Didsbury Point

Non Material Amendments

Project name: Didsbury Point
Project number: 8845
Client: Southway Devco

Following recent approval of the Section 73. submission this document aims to pick up all remaining non material amendments made to the consented residential development; Didsbury Point (planning application ref. 135235/FO/2022), during the design development stage.

Level 04 Floor Plan

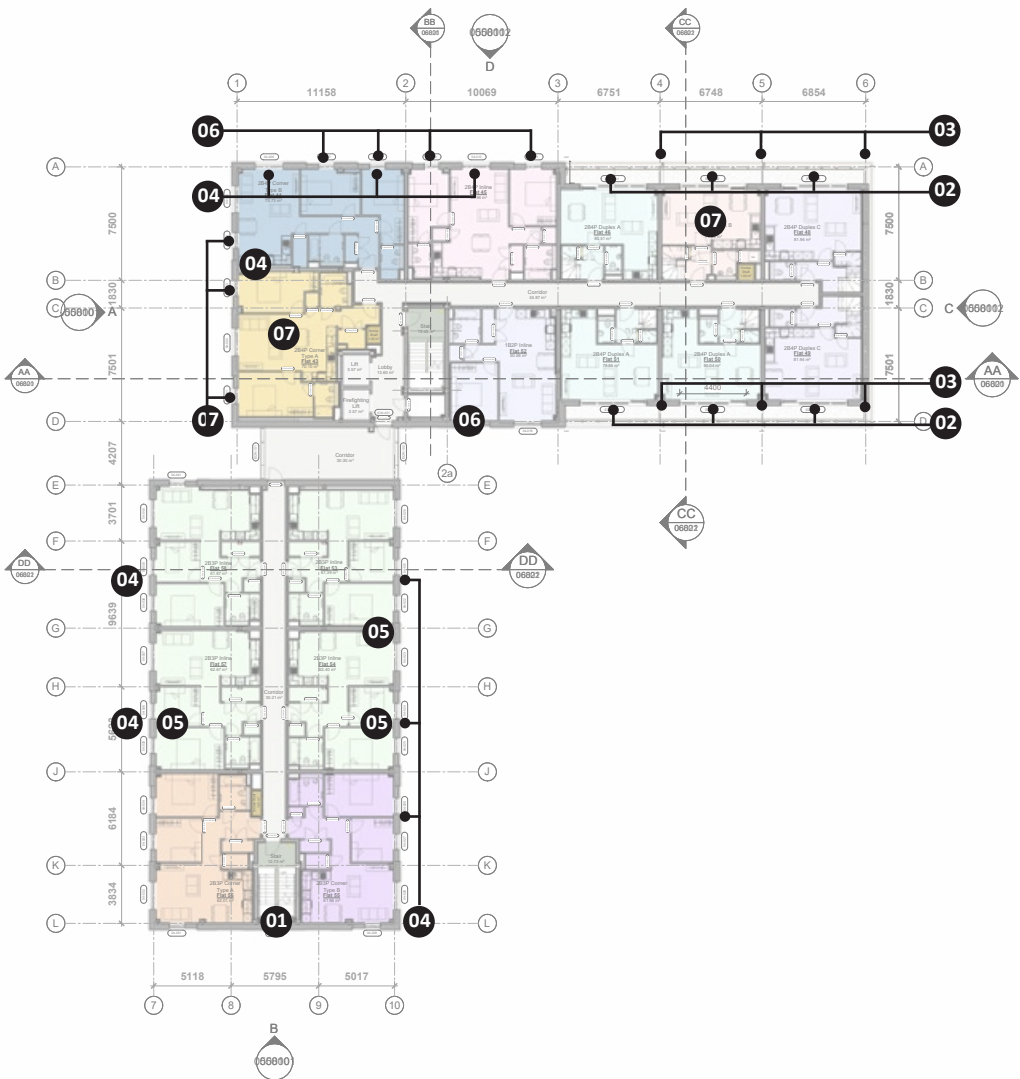
- 01. Windows to staircore replaced with opaque glazed panel
- 02. Glazed screens updated to '4 panel' arrangement with integrated patio door
- 03. Privacy screens added between and at end of duplexes at terrace level (x6 in total)
- 04. Window (& perforated panel) in column mirrored
- 05. Perforated spandrel panel added / removed from window column. See 'Proposed Bay Study Sh. 1' for details
- 06. Joints to double height windows with perforated panel added. See 'Proposed Bay Study Sh. 2' for details
- 07. Change to apartment areas (refer to detailed page on updates and rationale).

Typical Level 05 Floor Plan

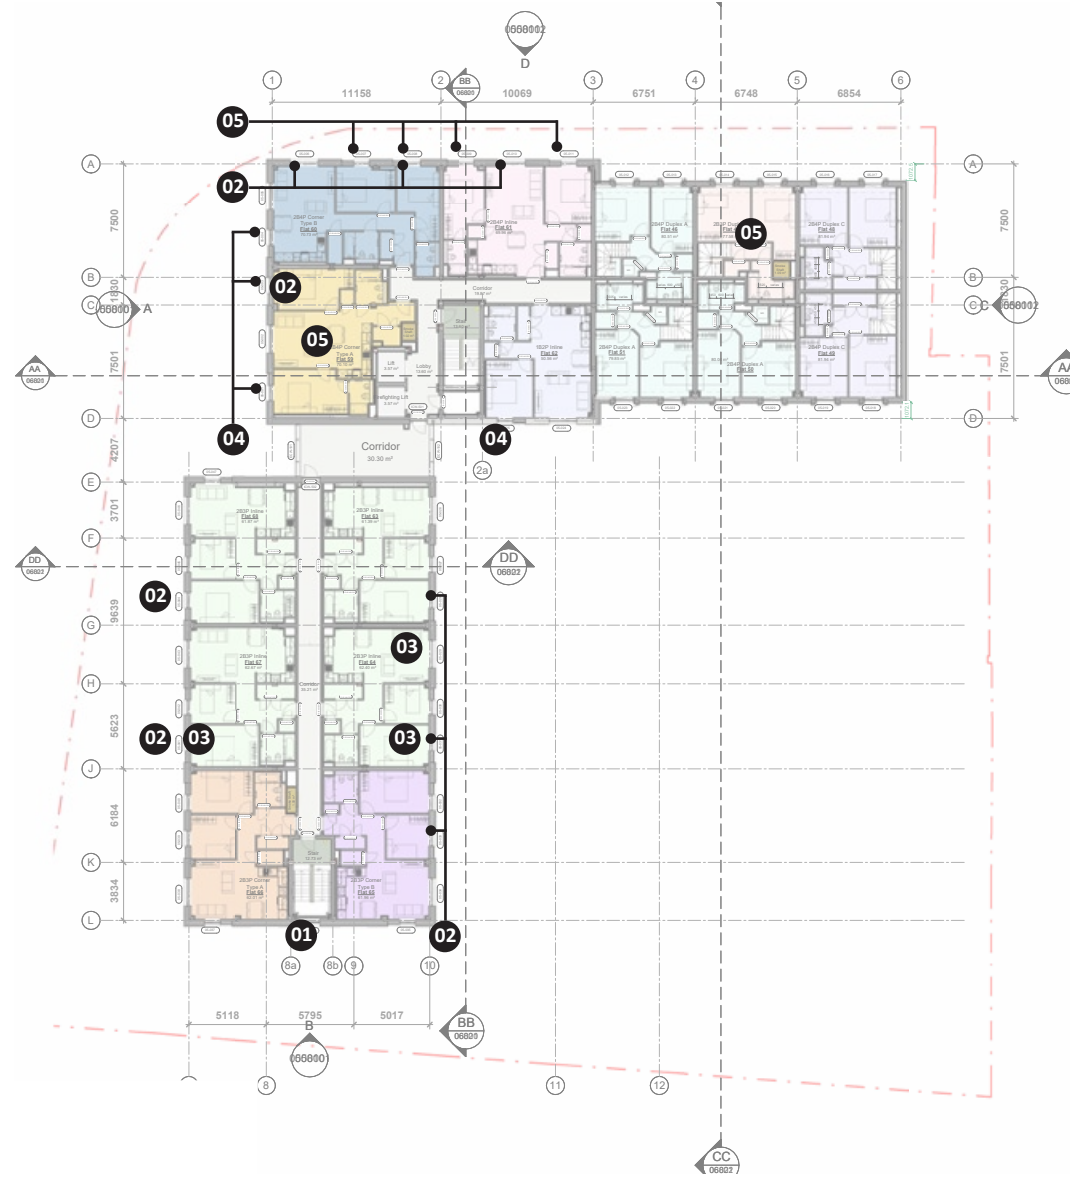
- 01. 'Windows to staircore replaced with opaque glazed panel.
- 02. Window (& perforated panel) in column mirrored
- 03. Perforated spandrel panel added / removed from window column. See 'Proposed Bay Study Sh. 1' for details
- 04. Joints to double height windows with perforated panel added. See 'Proposed Bay Study Sh. 2' for details
- 05. Change to apartment areas (refer to detailed page on updates and rationale).

Level 06 - 07 Floor Plan

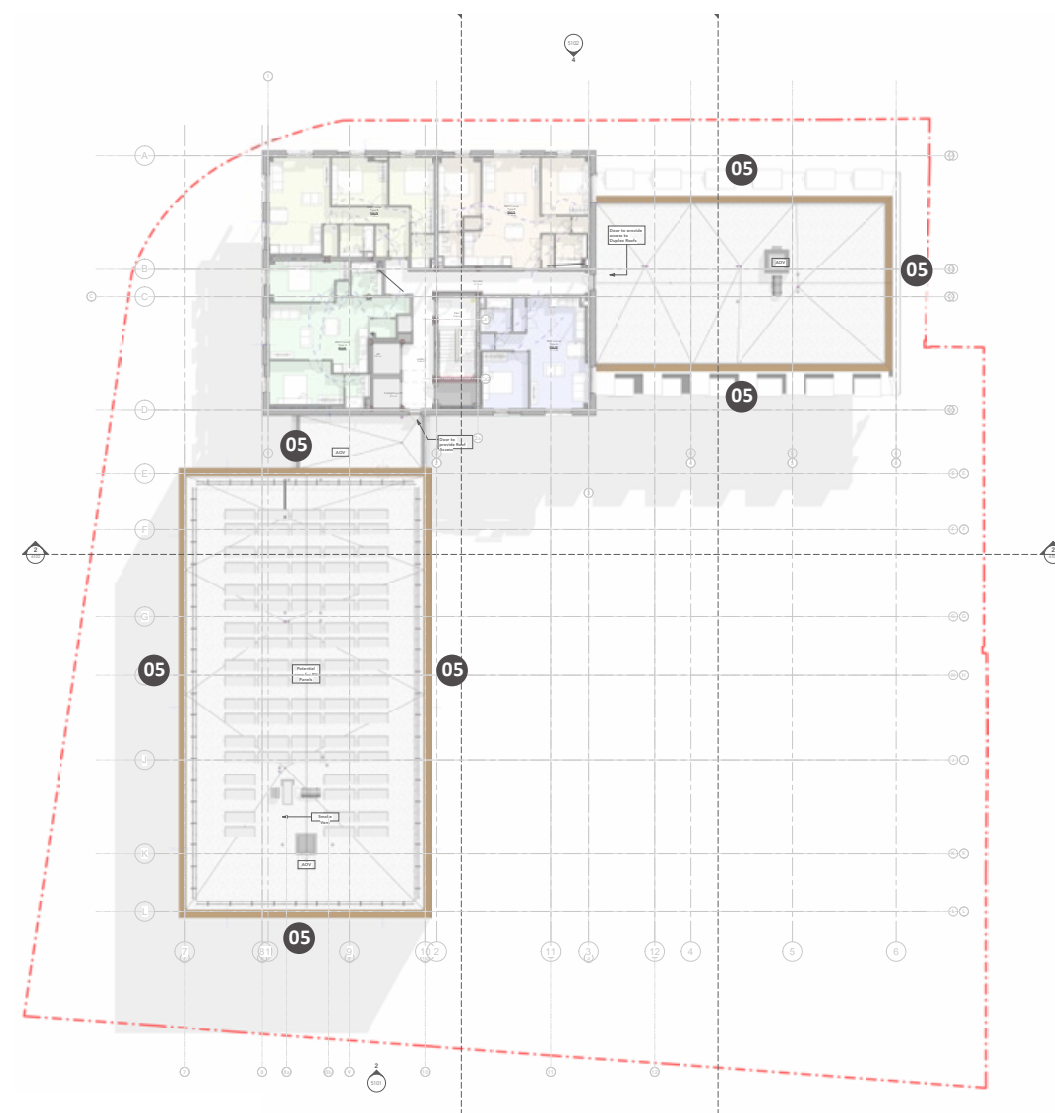
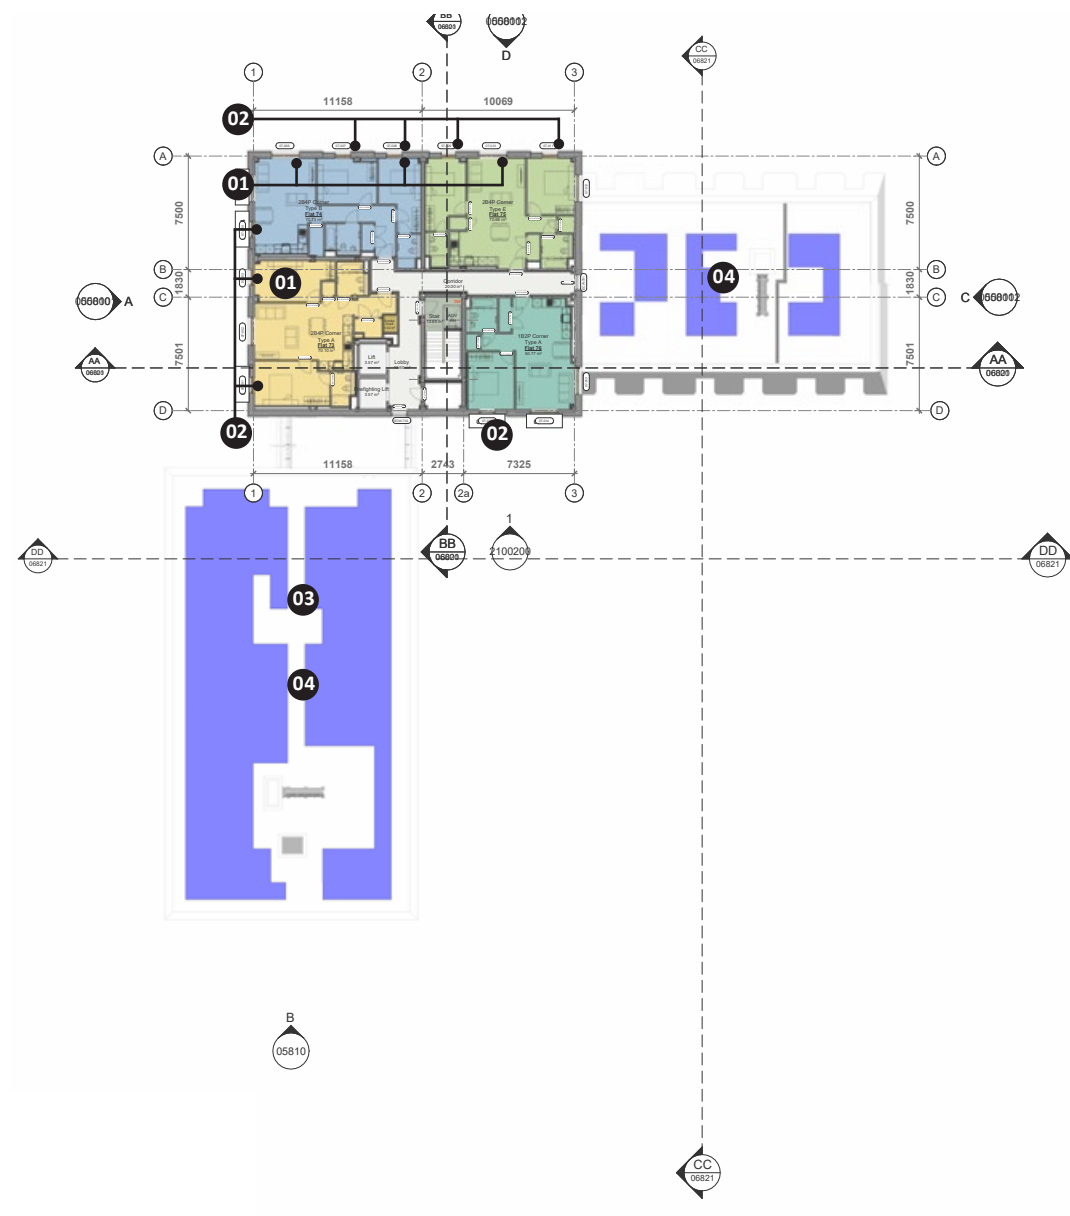
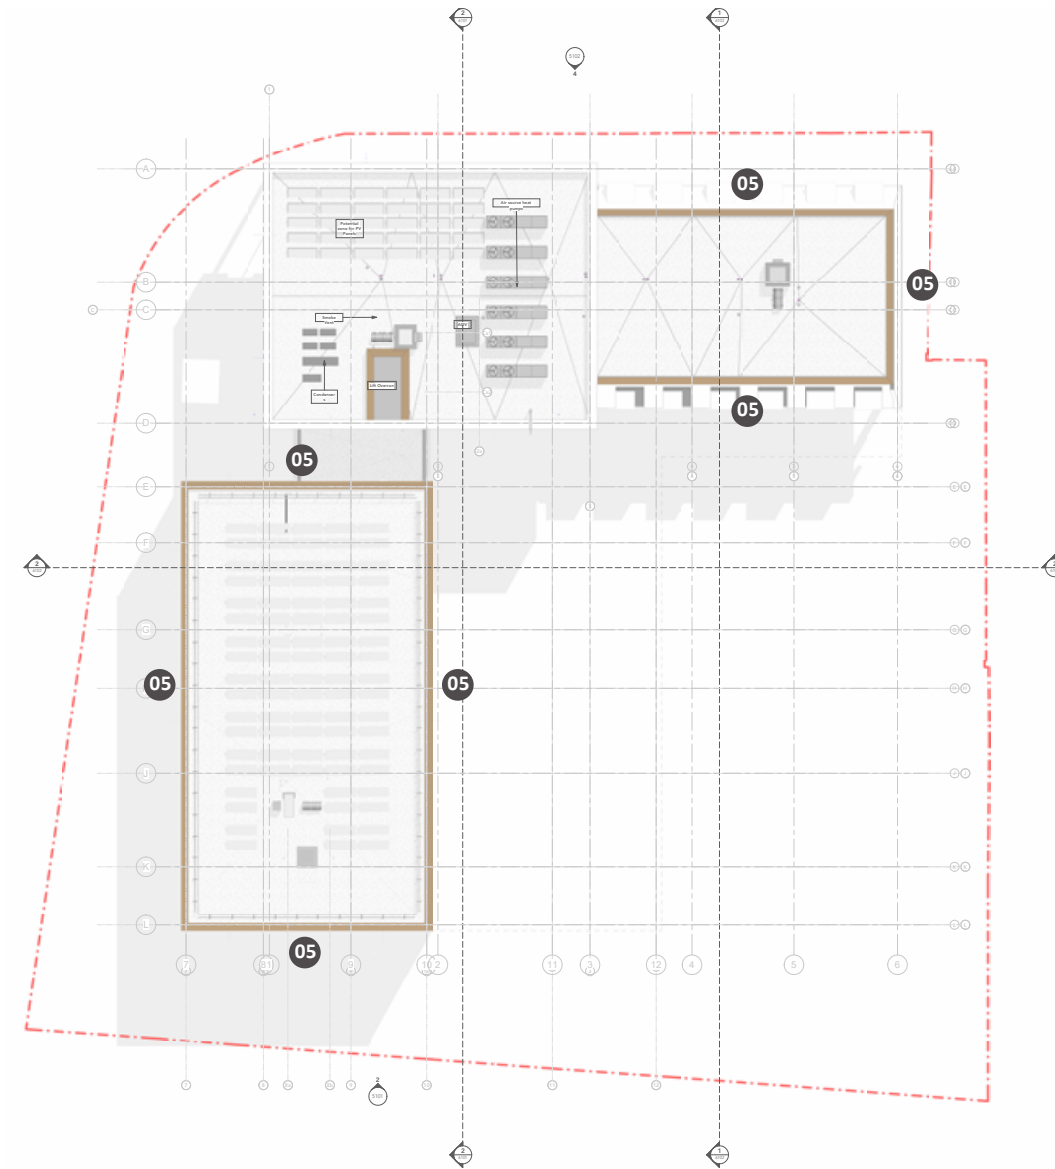
05. Lower block heights increased by 225, 268 or 995mm

01. Window (& perforated panel) in column mirrored

02. Joints to double height windows with perforated panel added. See 'Proposed Bay Study Sh. 2' for details

03. PV Zone — Approx. 270.1 m² Solar PV Coverage (Final layout by contractor)

04. Roof arrangement

Roof Plan

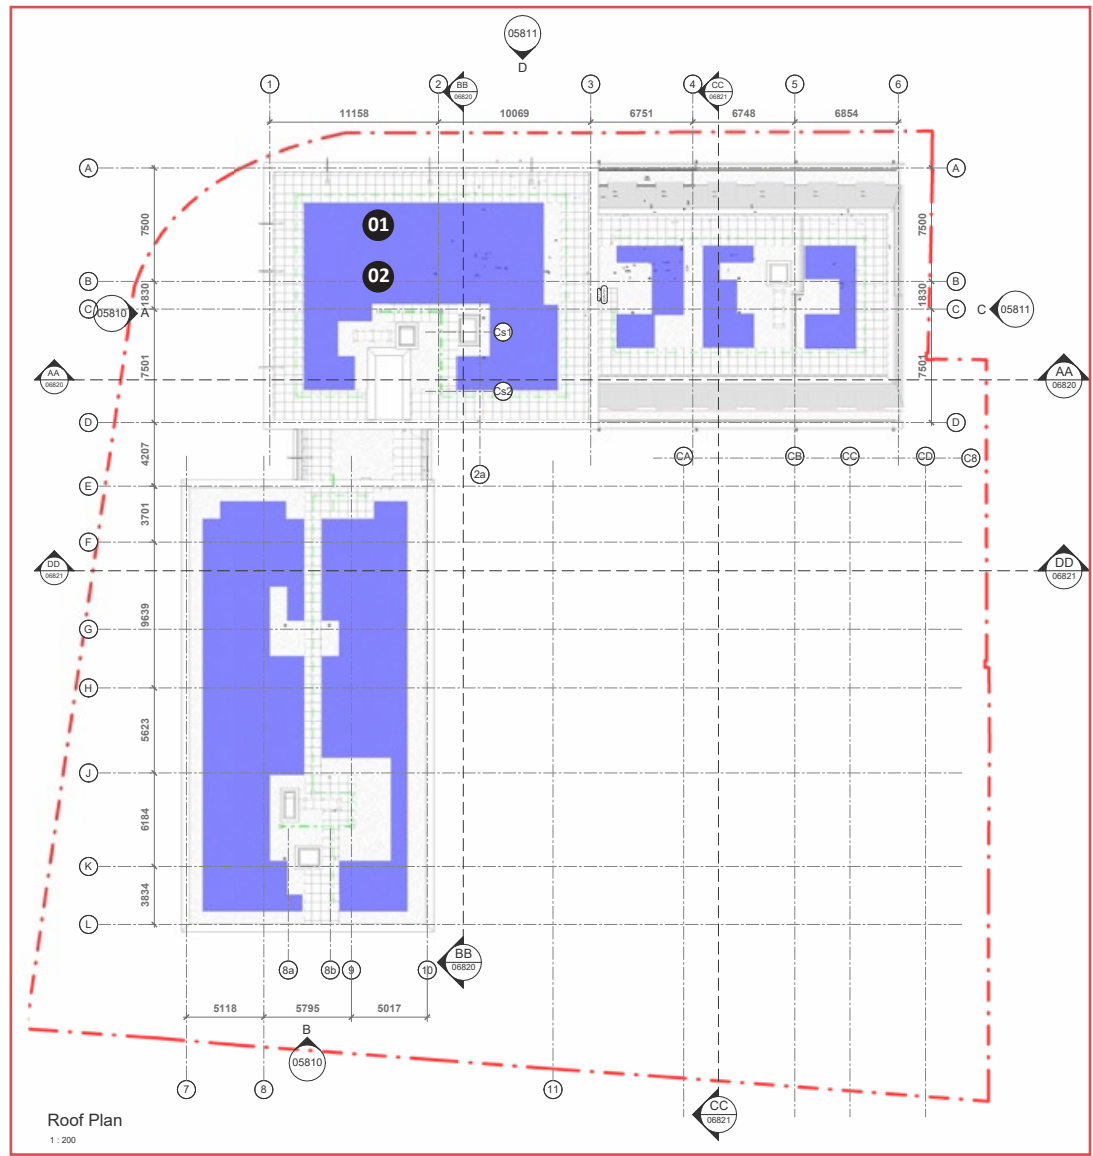
05. Lower block heights increased by 225, 268 or 995mm

01. PV Zone — Approx. 270.1 m² Solar PV Coverage to ensure EPC B achieved

02. Roof arrangement

Figure 1 - Duplex Apartment Type B (Planning Issue)

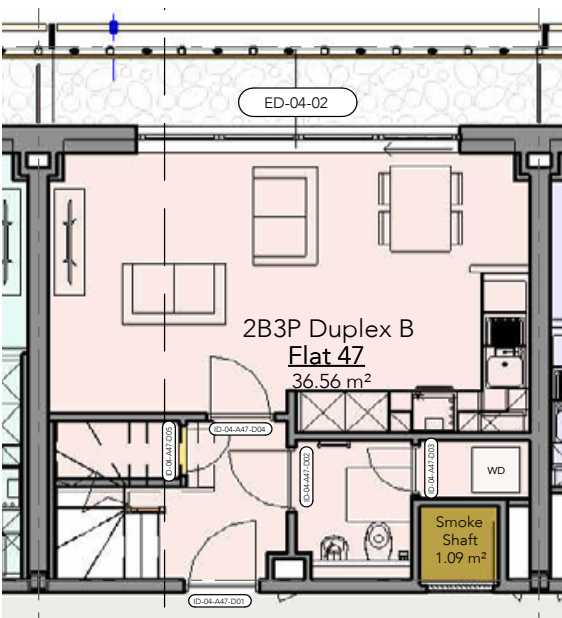
Duplex Type B has been subject to a number of iterative changes which have adversely effected the overall area assigned to this apartment. As such it has been changed from a 2 Bed 4 Person to a 2 Bed 3 Person layout in order to comply with the minimum nationally described space standards. Refer to Figures 1 &2. A summary of the impacts which have resulted in the reduced area are as follows:

- The external wall along the duplex terrace has progressively moved inward as the wall build-up has evolved. In order to maintain the terrace, the resulting interior space has been reduced.

- The addition of column encasements around the steel columns further reduced the apartment’s internal area. Initially deriving from fire protection requirements and later following additional acoustic requirements.

- Additional acoustic linings around beams as well as soundproofing to the stair and upper floor bathroom, have also reduced the usable space within the apartment by widening party walls and other partitions.

- The smoke shaft was redesigned to accommodate a new service riser, enabling soil vent pipes (SVPs) to vent at the roof level for lower apartments. This adjustment made room for additional services but affected the layout of Type B negatively.

- Under the Nationally Described Space Standard, area below 1500mm but above 900mm in head height should be calculated at half the floor area available. The area falling below 1500mm increased due to the build up depths associated with the pitched roof element confirmed through detail development at Stage 4.

Figure 3 - Corner Type A (Planning Issue)

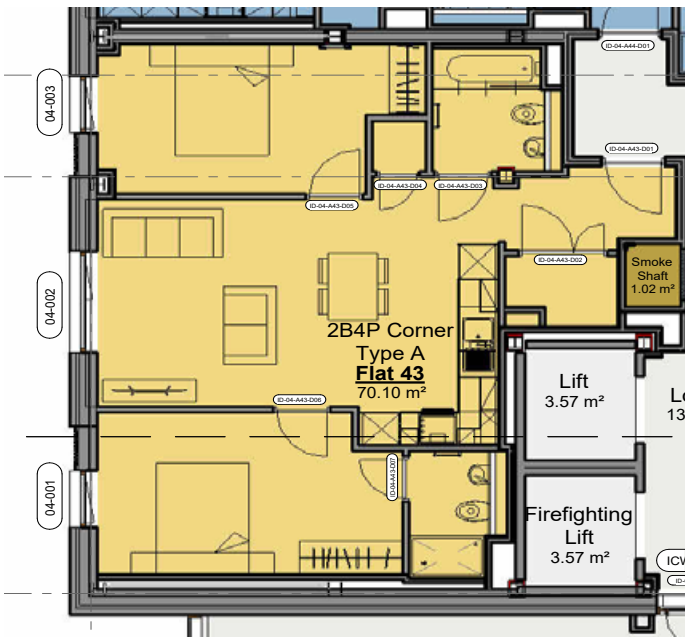
In order to mitigate the impact of a reduced apartment area in this instance - it is worth noting that changes around the lift shaft at Stage 4 had a positive impact on the area provision to the 6No. apartments adjacent to the core at each level. Originally anticipated as a 2 Bed 3 Person, these instances have subsequently been uplifted to a 2 Bed 4 Person type. The plan at planning vs. the latest iteration indicated in figures 3 & 4.
